## Solicitation Addendum

**Addendum No.:** 3  
**Solicitation No.:** 17-2001OV  
**Project No.:**  
**Solicitation Title:** Chiller and Exhaust Fan Replacement at the Water treatment Lab  
**Addendum Date:** October 26th, 2017  
**Procurement Contact:** Olga Valcich [olga.valcich@mymanatee.org](mailto:olga.valcich@mymanatee.org)

**IFB NO. 17-2001OV IS AMENDED AS SET FORTH HEREIN. RESPONSES TO QUESTIONS POSED BY PROSPECTIVE BIDDERS ARE PROVIDED BELOW. THIS ADDENDUM IS HEREBY INCORPORATED IN AND MADE A PART OF IFB NO. 17-2001OV CHILLER AND EXHAUST FAN REPLACEMENT AT THE WATER TREATMENT LAB.**

**PLAN SHEET CH-M3.1 MECHANICAL DETAILS**

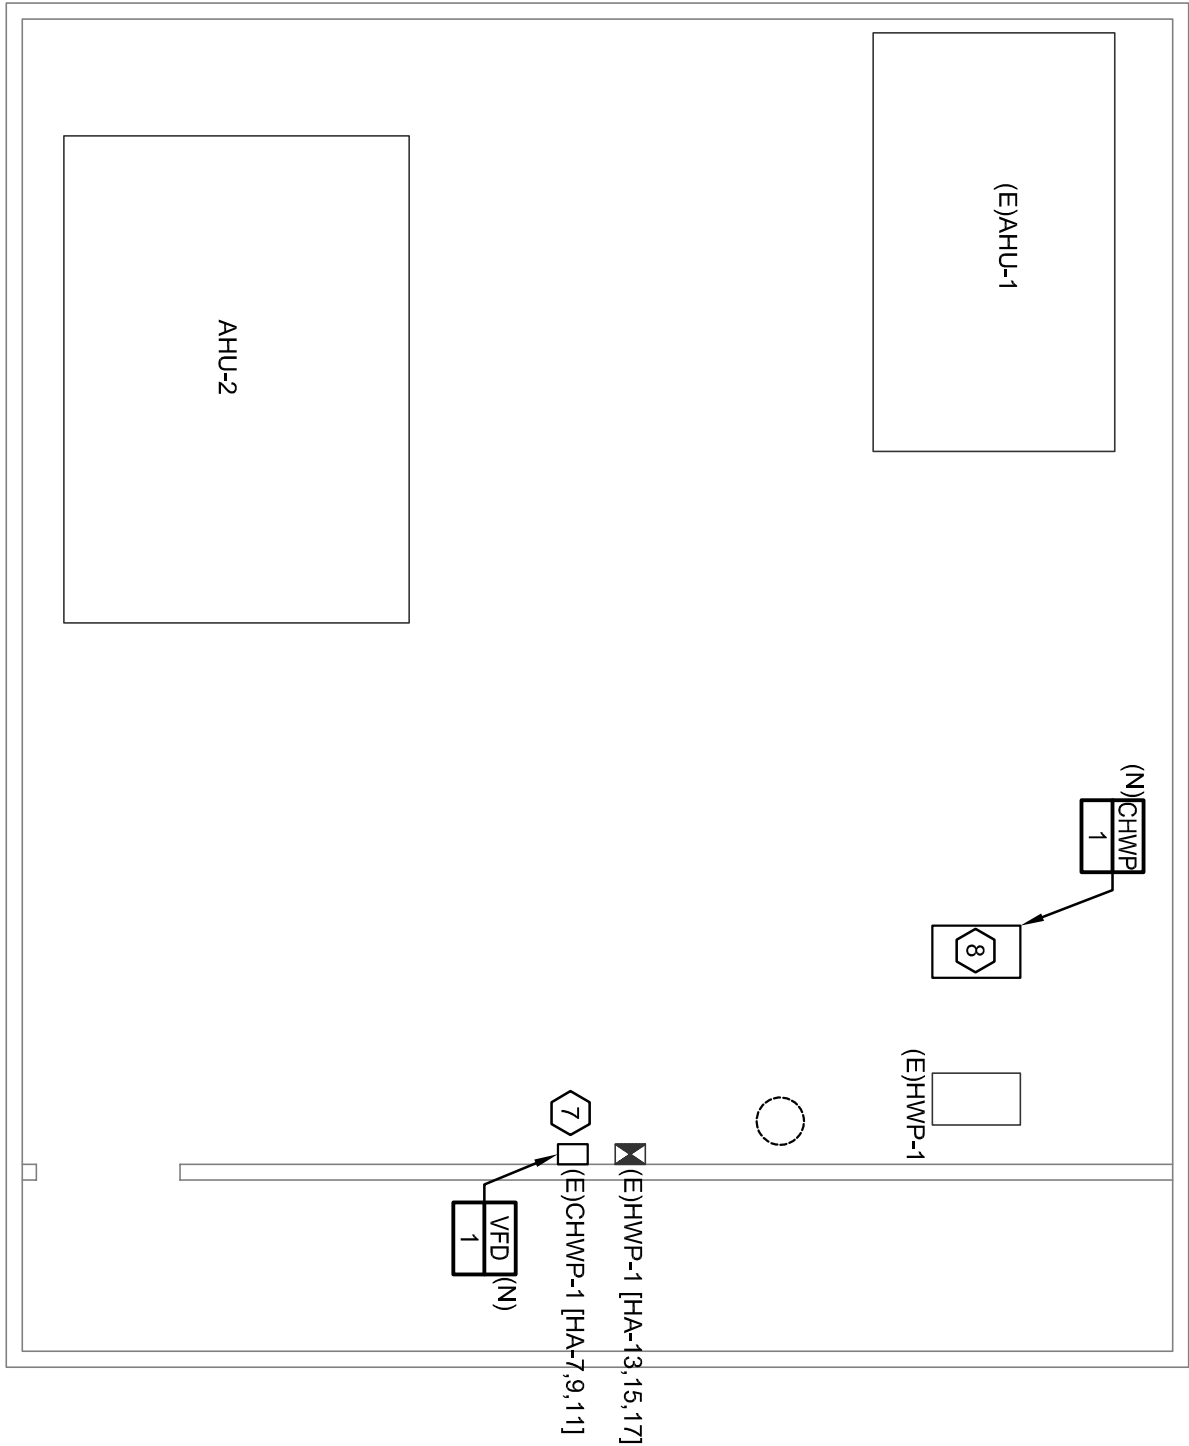
- "New water Pump schedule": Revised pump Selection CHWP-1. Motor remain unchanged.
- "New water Pump schedule": Note added to clarify connection of new pump to existing piping
- "Buffer Tank Schedule": Note added to clarify that chilled water supply and return piping connections on buffer tank, shall match line size, 4".

**PLAN SHEET CH-E2.0 ELECTRICAL CHILLER YARD RENOVATION PLAN**

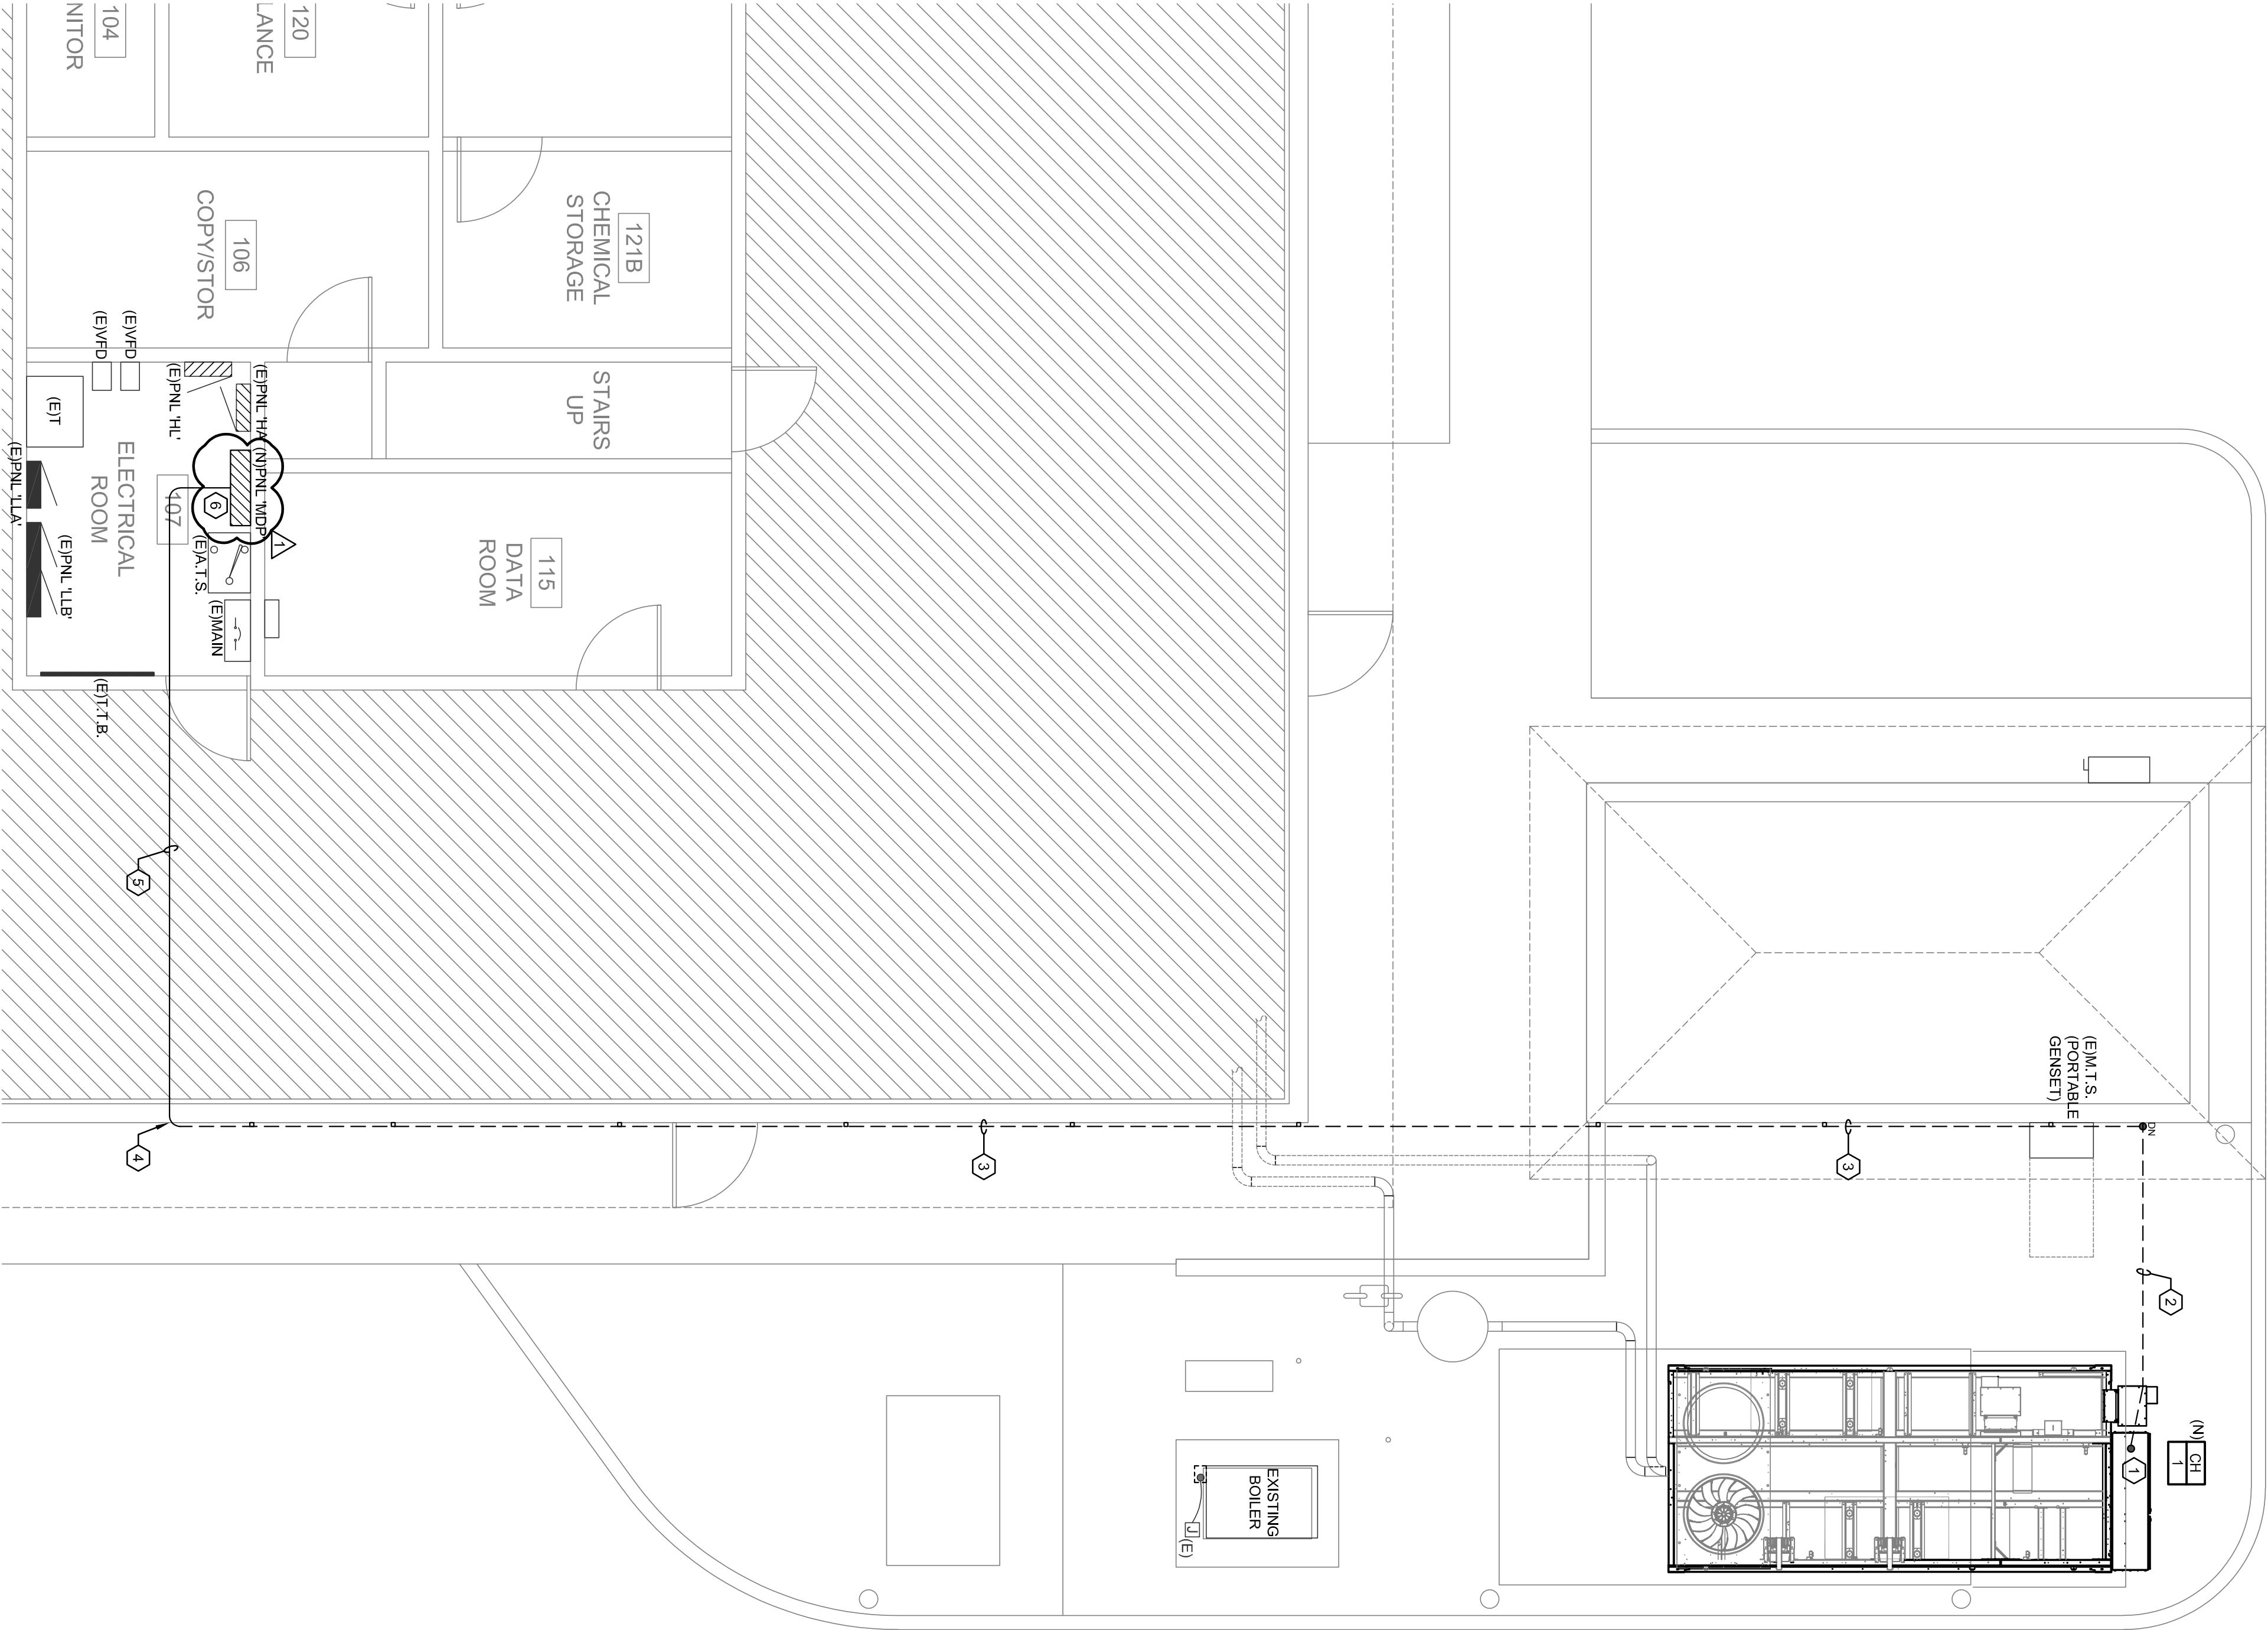
- Revised keynote 6 to specify replacing existing 600A 'MDP' panelboard with new panelboard.

- REPLACE EXISTING SQUARE D, 1 LINE 600 AMP 277/480 VOLT, 3 PHASE, 4 WIRE PANELBOARD WITH NEW SQUARE D, 1 LINE 600 AMP 277/480 VOLT, 3 PHASE, 4 WIRE PANELBOARD. NEW PANELBOARD MDP SHALL MATCH EXISTING PANELBOARD. NEW PANELBOARD SHALL BE MOUNTED TO EXISTING WALL FROM EXISTING WPT TO NEW WPT. CONTRACTOR SHALL PROVIDE ALL COATED NECESSARY BREAKER MOUNTING HARDWARE AND ADDITIONAL BLANK PLATES AS REQUIRED. REFER TO PANEL SCHEDULES ON SHEET E3.0 FOR MORE INFORMATION.

**PLAN SHEET CH-E3.0 ELECTRICAL RISER DIAGRAM & SCHEDULES**

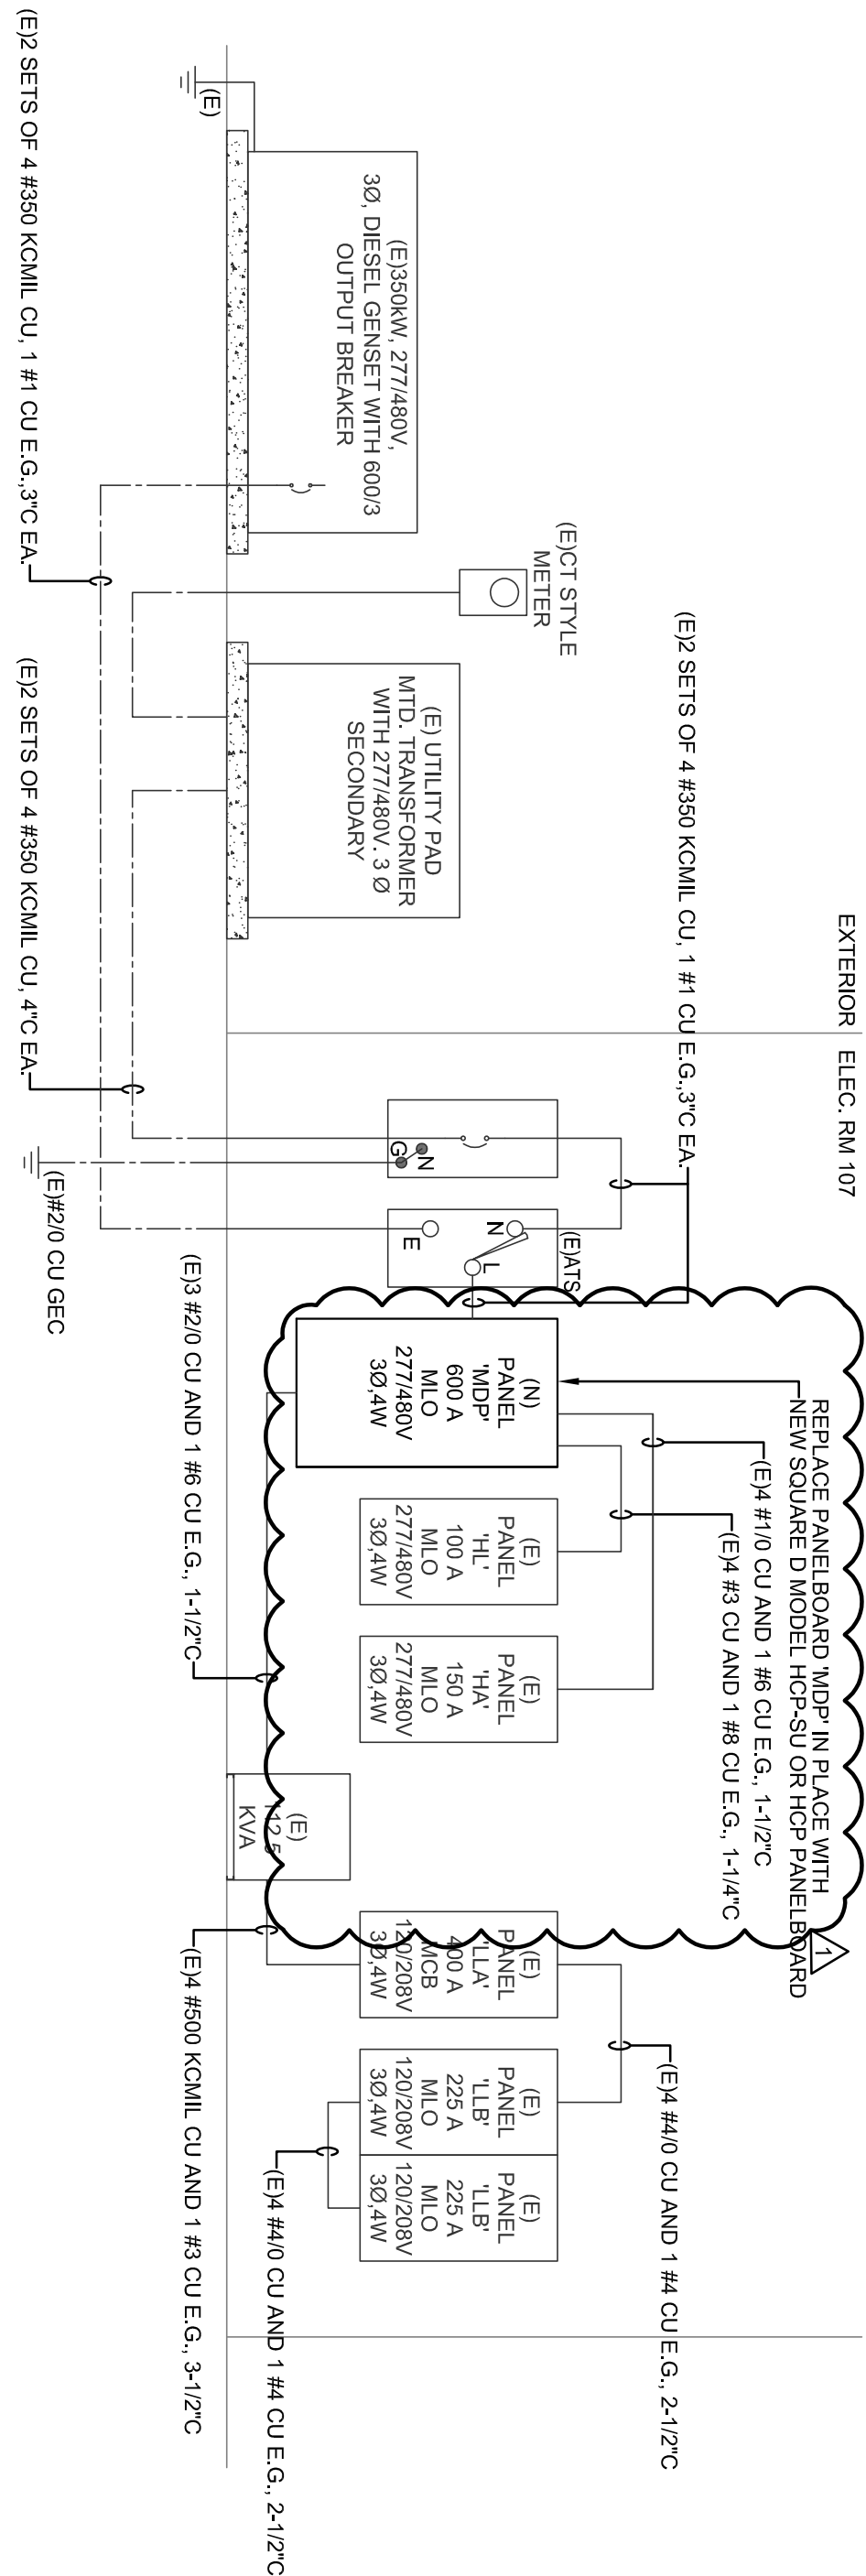
- Revised panel schedules and riser diagram to show existing 'MDP' panelboard replaced with new panelboard.
